## Executive Director's Recommendation

Commission Meeting: May 5, 2016

<b>PROJECT</b> <b>Arlington Memorial Bridge Rehabilitation</b> Southwest Washington, DC	<b>NCPC FILE NUMBER</b> 7547
<b>SUBMITTED BY</b> United States Department of the Interior National Park Service	<b>NCPC MAP FILE NUMBER</b> 75.00.01(48.00)43884
<b>REVIEW AUTHORITY</b> Federal Projects in the District per 40 U.S.C. § 8722(b)(1) and (d)	<b>APPLICANT'S REQUEST</b> Approval of comments on concept design
	<b>PROPOSED ACTION</b> Approve comments as requested
	<b>ACTION ITEM TYPE</b> Presentation

# **Arlington Memorial Bridge Rehabilitation**

# Alternative 1B – Replace Bascule Span with Variable Depth Girders

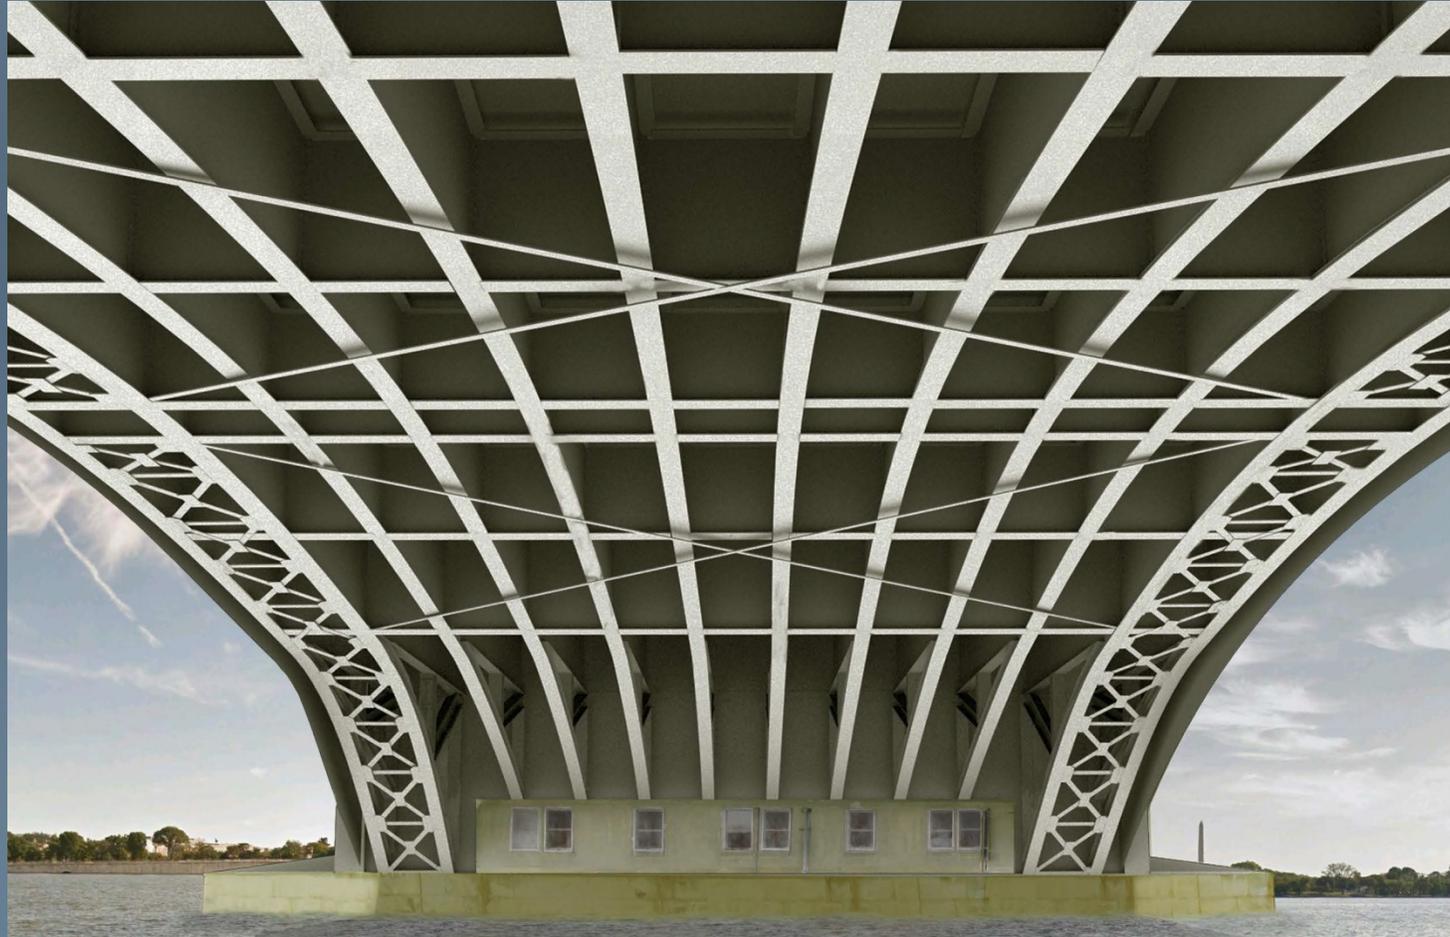
**Supports** Alternative 1B (Replace Bascule Span with Variable Depth Girders) as the preferred alternative for the Arlington Bridge Rehabilitation, as it best balances historic preservation goals with constructability, maintenance and cost.

The NPS-preferred Alternative 1B reflects the original bascule design in its form and the use of steel, without attempting to recreate the historic design. The girder shape echoes the original arch of the bascule, while outboard trusses would reflect the current span design. Further, the variable depth girders would require less effort to maintain due to the reduced number of structural elements and joints as compared to Alternatives 2 and 3. Therefore, staff recommends the **Commission supports Alternative 1B (Replace Bascule Span with Variable Depth Girders) as the preferred alternative for the Arlington Bridge Rehabilitation, as it best balances historic preservation goals with constructability, maintenance and cost.**

- **1B – Replace Bascule Span with Variable Depth Girders (Preferred)**
  - Some visual similarity to existing bridge
  - Simpler maintenance (fewer elements)
  - Lower construction and maintenance costs than #3
  - Allows for partial or full bridge closures
  - Trunnion posts/counterweight removed

## Character Defining Features Retained in Alternative 1B

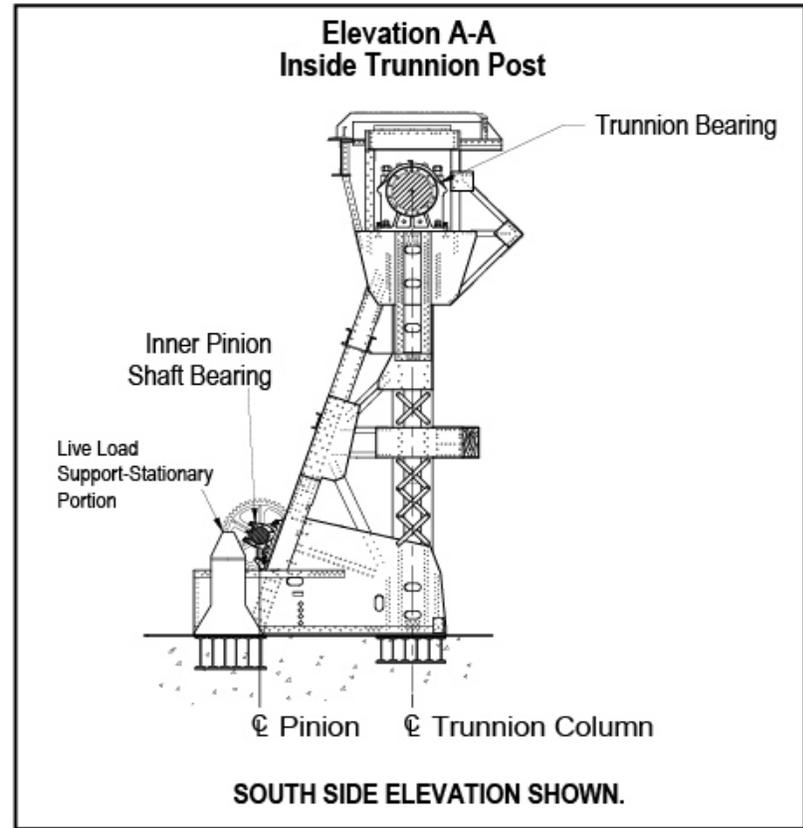
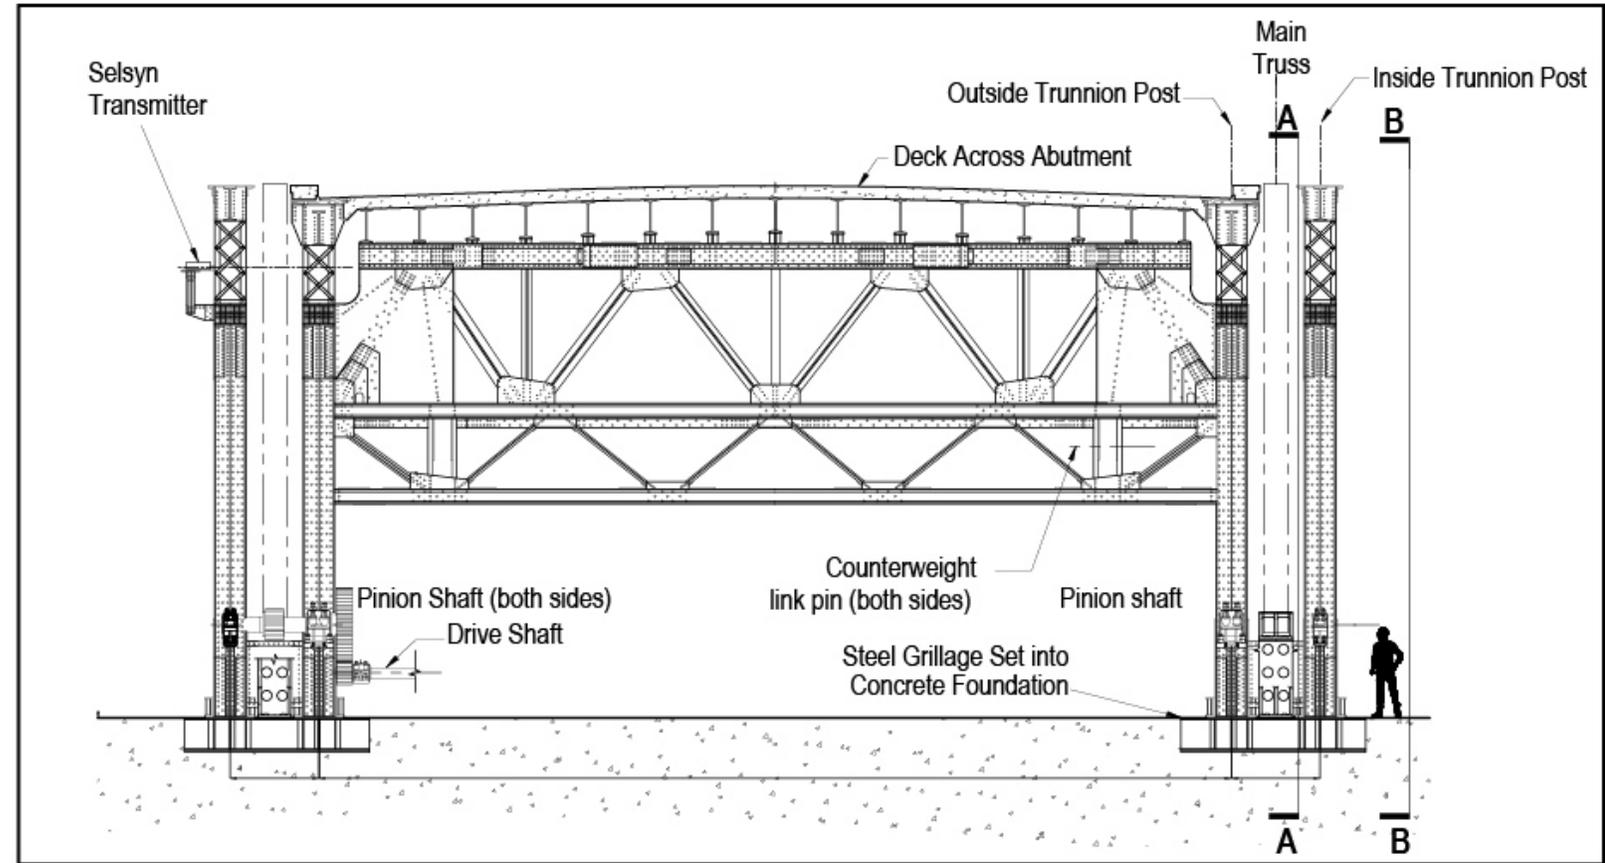
Guard and Overseer Cabins, Store Room, Operators Room, Mechanical Room

Steel Trusses, Bascule leaves, Counterweights, Trunnion Posts, Drive Shafts
